Project	<b>IEEE 802.16 Broadband Wireless Access Working Group</b> < <a href="http://ieee802.org/16">http://ieee802.org/16</a> >	
Title	<b>The optimization for the transmission of the MOB-TRF-IND message in Sleep Mode.</b>	
Date Submitted	<b>2004-11-04</b>	
Source(s)	Kiseon Ryu, Yongho Kim, Beomjoon Kim, Yongwon Kwak, Changjae Lee LG Electronics, Inc. 533, Hogye-1dong, Dongan-gu, Anyang-shi, Kyongki-do, Korea	Voice: 82-31-450-4387 Fax: 82-31-450-7912 <a href="mailto:ksryu, ronnykim, beom, yongwon, cjlee16@lge.com">[mailto:ksryu, ronnykim, beom, yongwon, cjlee16@lge.com]</a>
Re:	Response to Sponsor Ballot	
Abstract	This document contains suggestions to reduce the transmission of the MOB-TRF-IND message.	
Purpose	This document is submitted for review by 802.16e Working Group members.	
Notice	This document has been prepared to assist IEEE 802.16. It is offered as a basis for discussion and is not binding on the contributing individual(s) or organization(s). The material in this document is subject to change in form and content after further study. The contributor(s) reserve(s) the right to add, amend or withdraw material contained herein.

# The optimization for the transmission of th

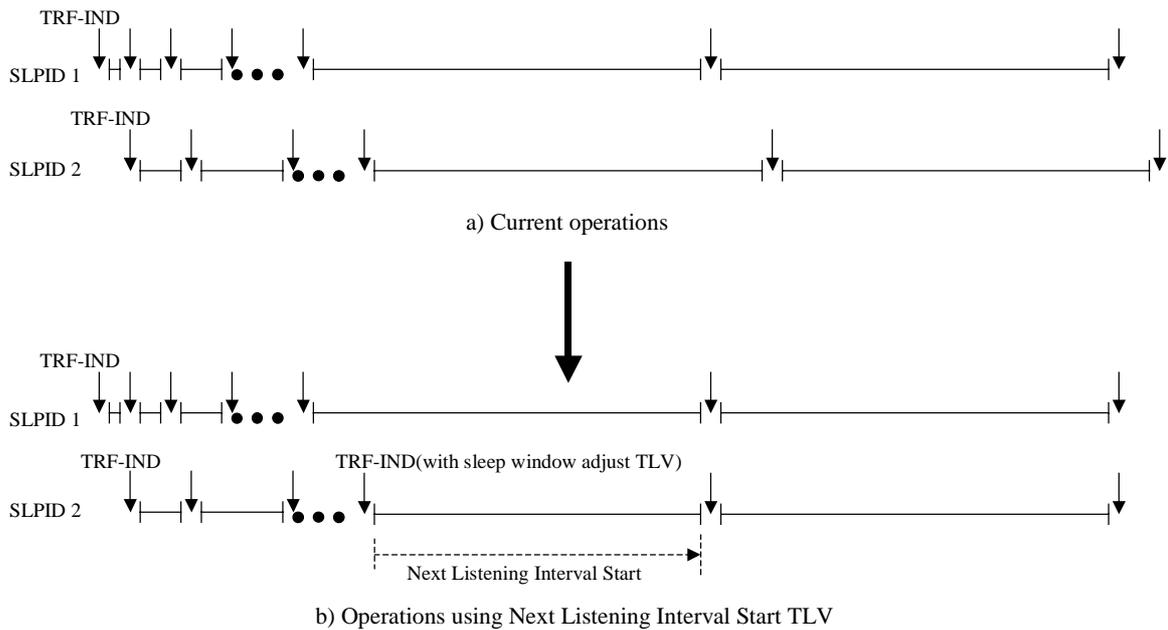
Adjustment of timing can be achieved with either traffic indication or ranging response.

Both the MOB-TRF-IND message and RNG-RSP message can include the proposed parameter as follows:

- *Next\_Listening\_Interval\_Start*

This parameter indicates the frame offset in which the next listening window start. When the MSS receives this parameter, it shall adjust the sleep interval to the value of the indication. However, this adjustment of sleep interval shall not affect the sleep-window update algorithm defined in the current draft, and the next sleep-window shall be set to the value calculated through the original sleep-window update algorithm.

The following figure shows an operational example of the proposed scheme.
